APPEAL SUMMARY

Appeal ID: 22221	Project Address: 1750 SW Yamhill St
Hearing Date: 12/11/19	Appellant Name: Tom Jaleski
Case No.: B-020	Appellant Phone: (503) 488-5651
Appeal Type: Building	Plans Examiner/Inspector: Kathy Aulwes, Corey Stanley
Project Type: commercial	Stories: 9 Occupancy: B, A-3, M, S-2 Construction Type: I-A
Building/Business Name: Canvas at Press Blocks	Fire Sprinklers: Yes - Throughout
Appeal Involves: Reconsideration of appeal	LUR or Permit Application No.: 17-182179-CO
Plan Submitted Option: pdf [File 1] [File 2]	Proposed use: Commercial

Engineering Judgment Report

Fire Rating of Steel Beams Protected with Intumescent Coating

Figure 1: Proposed design (typ). Intumescent fireproofing is shown with a minimum 1/2" overlap onto the roof decking

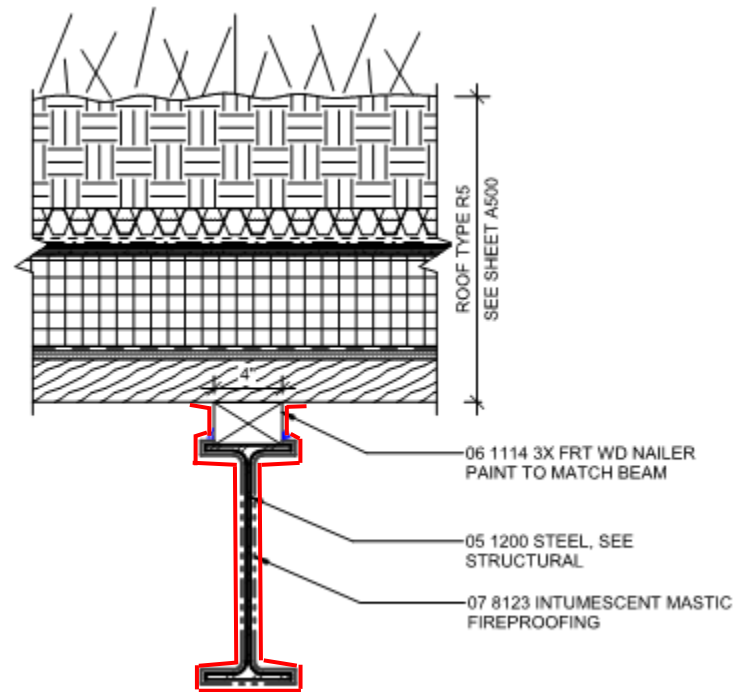
Steel beams frame the roof system and are protected by intumescent coating where they are visible. One- and two-hour fire ratings are required for these beams depending on whether they are primary structural framing or secondary members supporting the roof. The following beams and corresponding rating requirements are proposed to frame the roof:

Intumescent coating will be applied to the beams in accordance with UL design thickness required to achieve a 1- or 2-hour fire-rating as required by code.

Note: Primer (CarboClylic 3359-DTM) shall be continuous around the entire beam and continuing over the wood blocking and overlapping 1" onto the roof decking. Primer is also listed as a topcoat.

2. Alternate 1 and 2 hour intumescent roof framing beam assemblies with engineering analysis: Granted as proposed.

Figure 3b: Comparison Graph-UL N645 vs N614

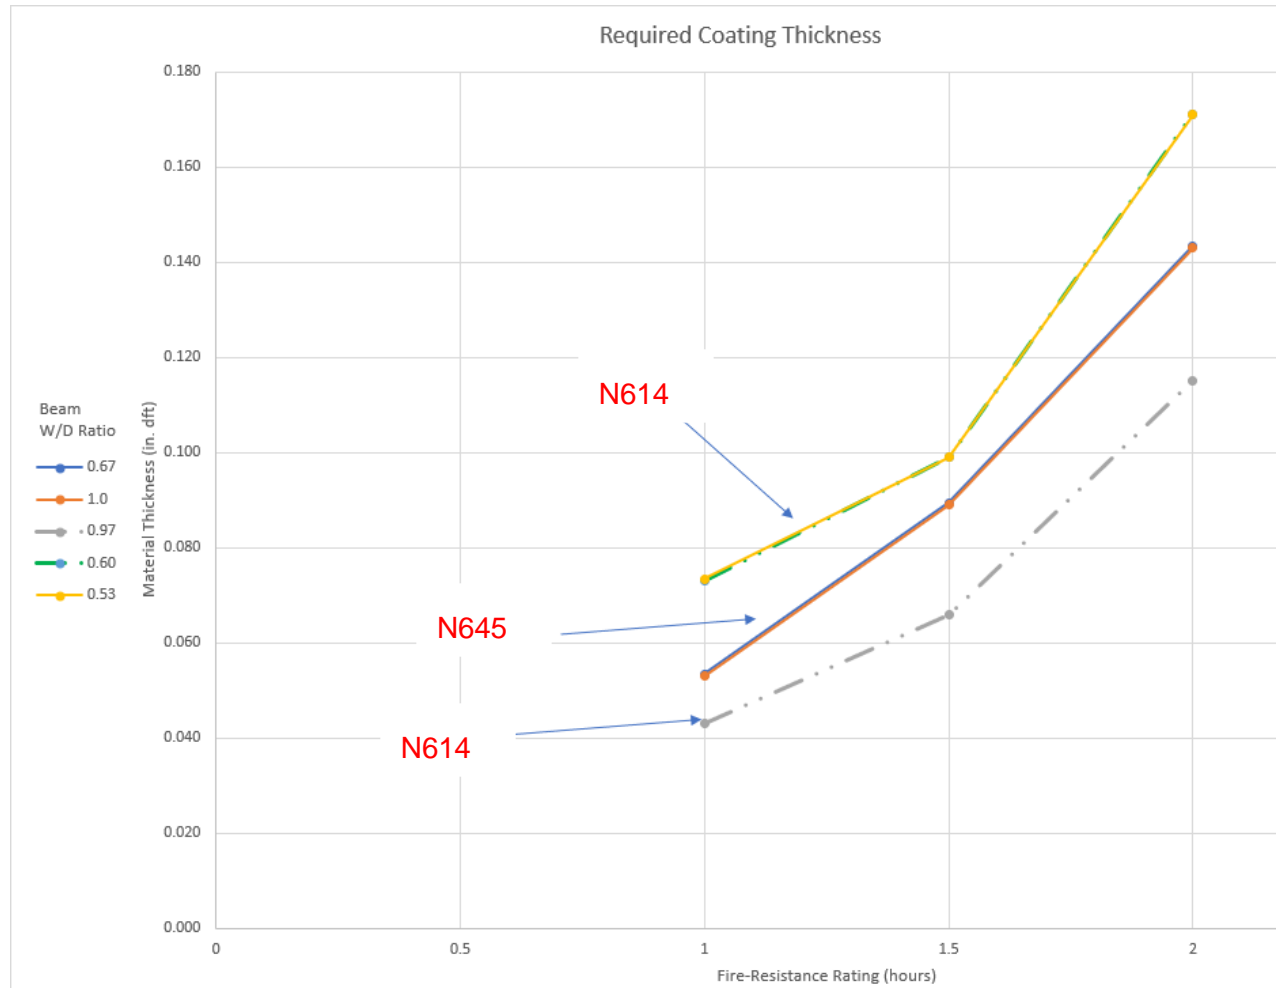
Intumescent will be applied to the beams in accordance with UL N645 with the thickness required to achieve a 1- or 2-hour fire-rating. The proposed design is compared to UL N645 and N614 shown in Fig.2 and analyzed in Graph below. Limited Testing is provided for the proposed Carboline intumescent coating, while Isolatek provides tables for Beams lower W/D Ratios. The comparison table below details how the protection thicknesses are similar for Isolatek WB3 (N614) and the Carboline coating tested under UL N645. N645 is tested down to a W/D ratio of 0.67, while the project is utilizing beams with W/D ratios of 0.534 (W14x22) and 0.606 (W10x22) The W/D ratio of the thinnest member is 20% lighter than the smallest beam tested under N645. When compared to N614, the intumescent thickness for the W14x22 is 20% thicker, which falls in line with a reasonable extrapolated thickness.

1. W10x22 (0.606)	N614-1 Hr	73 Mils
2. W10x22 (0.606)	N614-2 Hr	99 Mils
3. W14x22 (0.534)	N614-1 Hr	73 Mils
4. W14x22 (0.534)	N614-2 Hr	99 Mils

The proposed roof framing beam assemblies have been compared to UL listed design UL N645 and N614. The proposed beam assemblies will comply with the required 1- and 2-hr fire resistance requirement if protected with the Intumescent thicknesses in Table 1 above. Based on the review of the tested data provided in the table and graph above, the N614 thickness can be utilized for these beams. The coating thickness shall continue over the wood blocking and onto the roof decking.

Figure 1: Proposed design (typ). SFRM fireproofing is shown with a minimum 1" overlap onto the roof assembly.

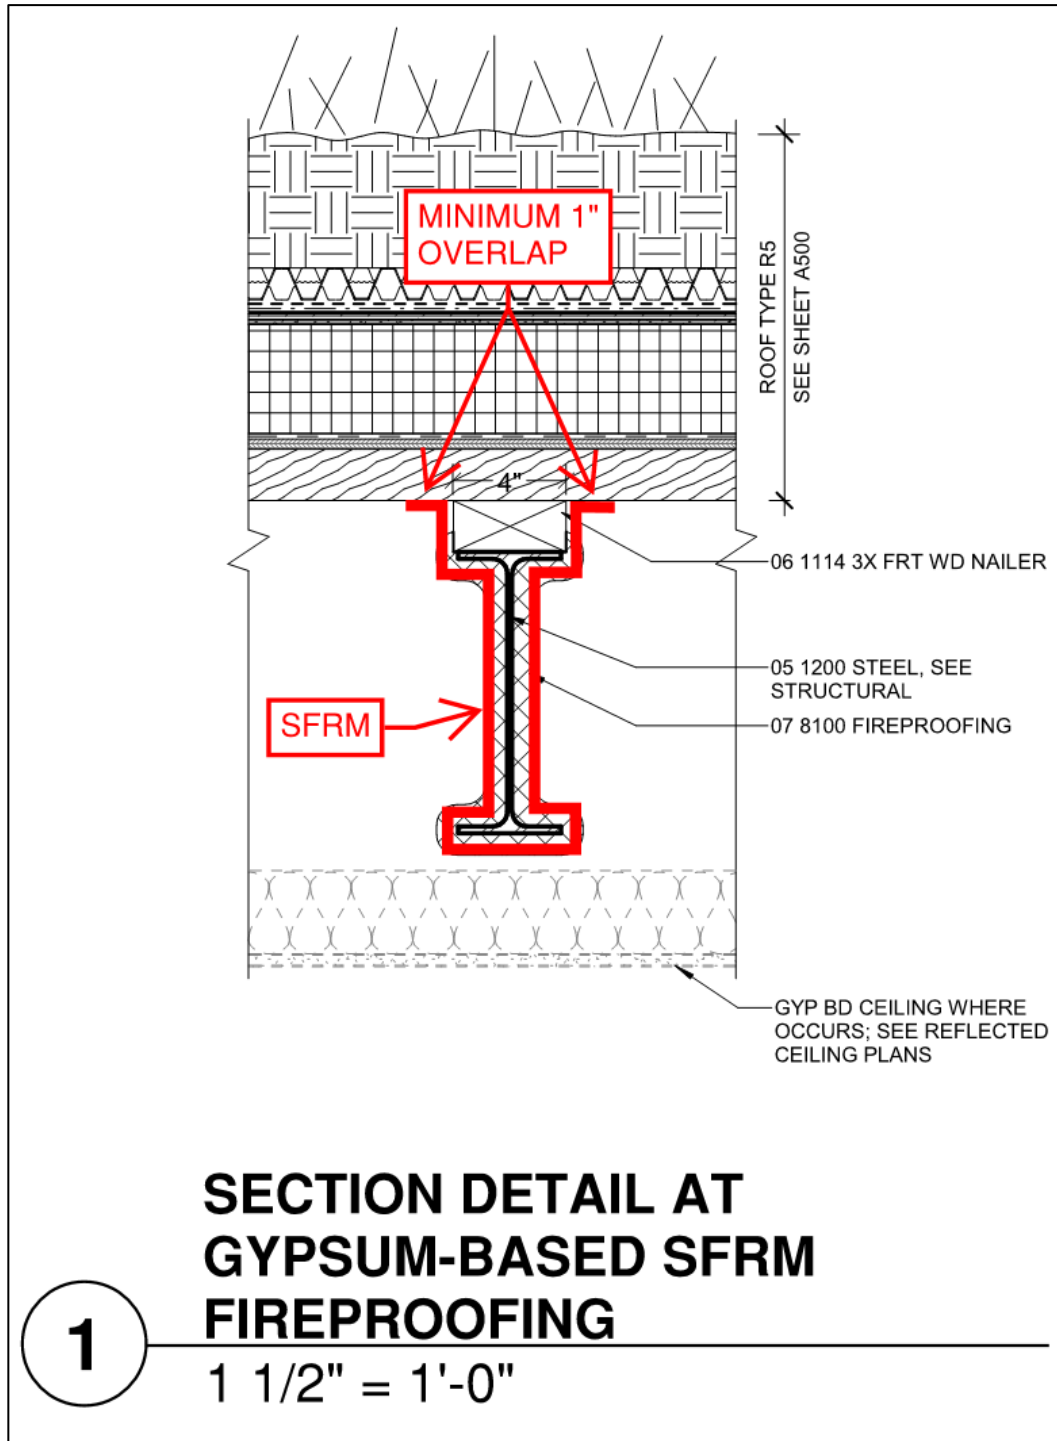
Steel beams frame the roof system and are protected by SFRM where they are concealed from view. One- and two-hour fire ratings are required for these beams depending on whether they are primary structural framing or secondary members supporting the roof. The following beams and corresponding rating requirements are proposed to frame the roof:

SFRM will be applied to the beams in accordance with UL S721 with the thickness required to achieve a 1- or 2-hour fire-rating as required by code. Figure 1 shows the details of the proposed SFRM application.

1. Alternate 1 and 2 hour SFRM roof framing beam assemblies with engineering analysis: Granted as proposed.

Figure 2: UL S721

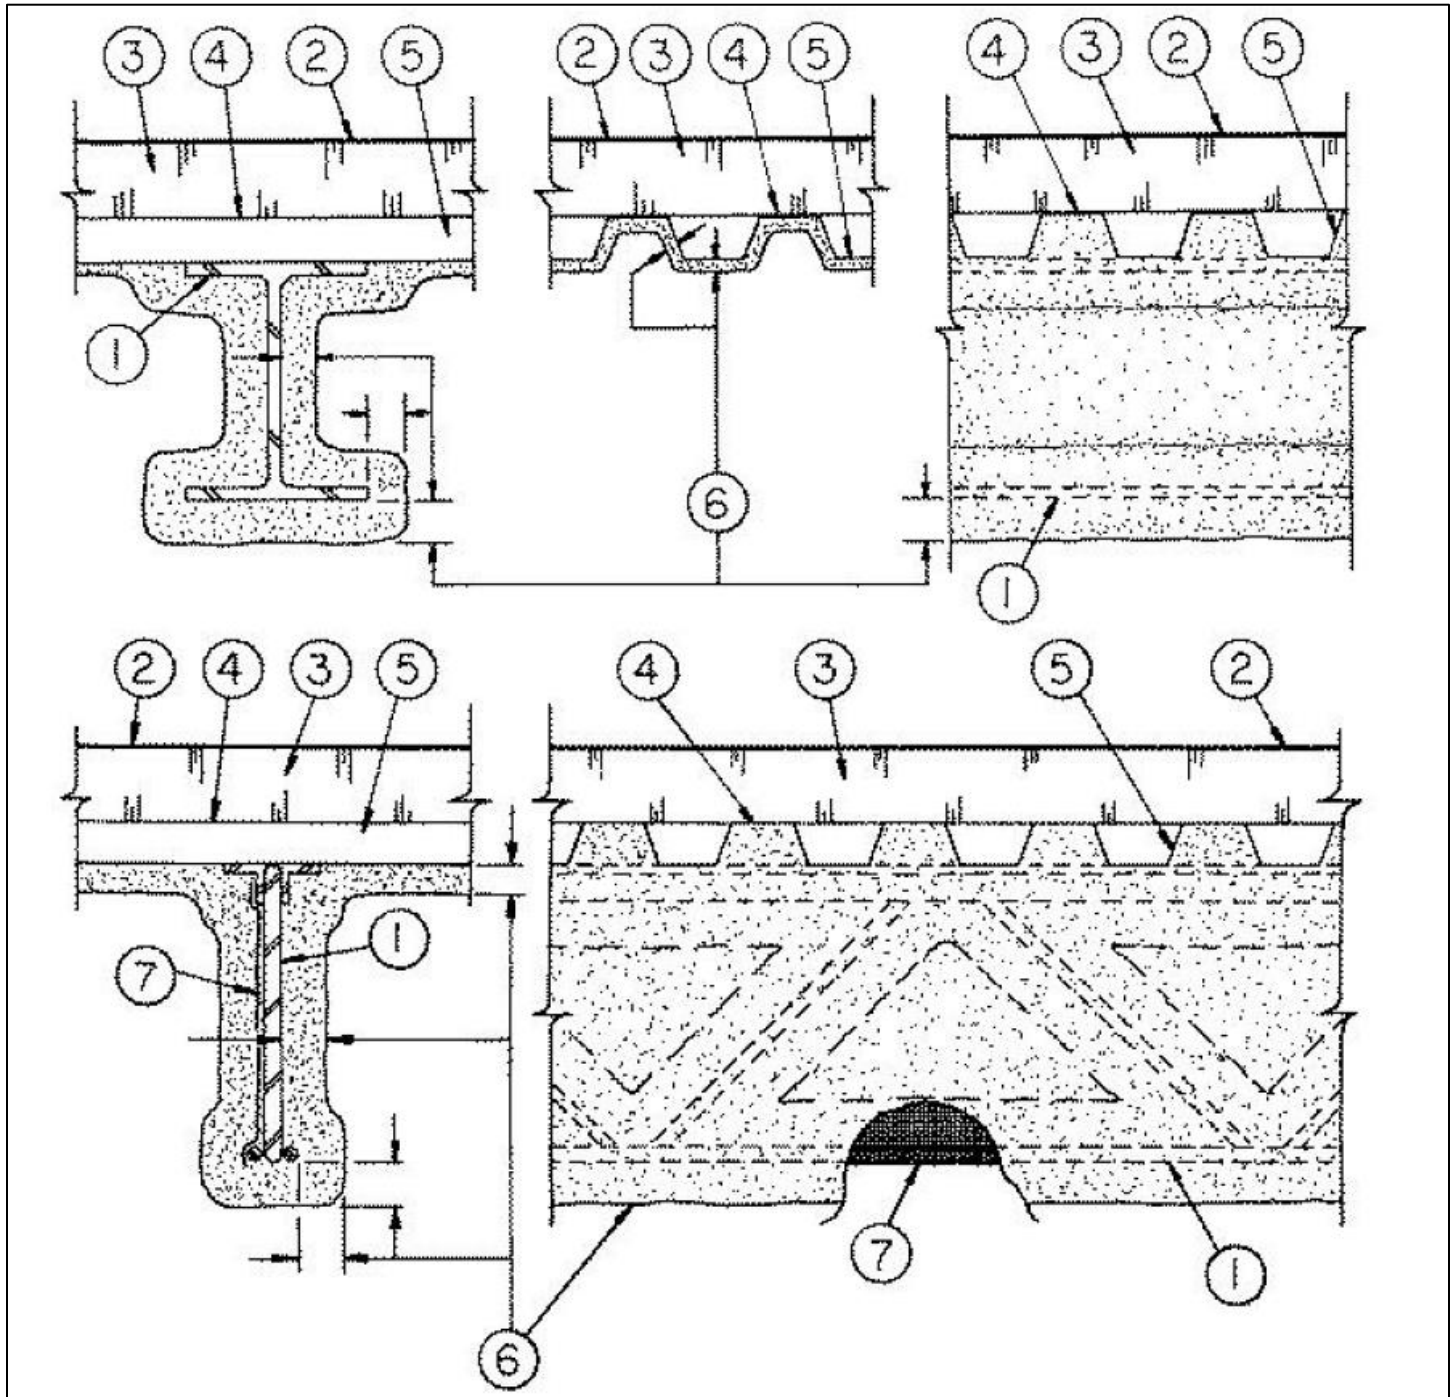
SFRM will be applied to the beams in accordance with UL S721 with the thickness required to achieve a 1- or 2-hour fire-rating. The proposed design is compared to UL S721 shown in Figure 2 and analyzed in Table 1 below.

Element	UL Assembly Design No. S721	Proposed Assembly
1. Steel Supports	W6x16 min size steel beam, 10K1, 12K3 or 14K1 min size steel joists. Note: When 10K1 or 12K1 joists are used, they will be limited to a max tensile stress of 26,000 psi.	1-hour steel beam minimum size is W8X10. 2-hour steel beam minimum size is W10X12 See Appendix 1 for Isolatek Unrestrained Beam Protected Roof Deck SFRM Thickness for UL S721.

The proposed roof framing beam assemblies have been compared to UL listed design UL S721. The proposed beam assemblies will comply with the required 1- and 2-hr fire resistance requirement if protected with the prescribed SFRM thickness.
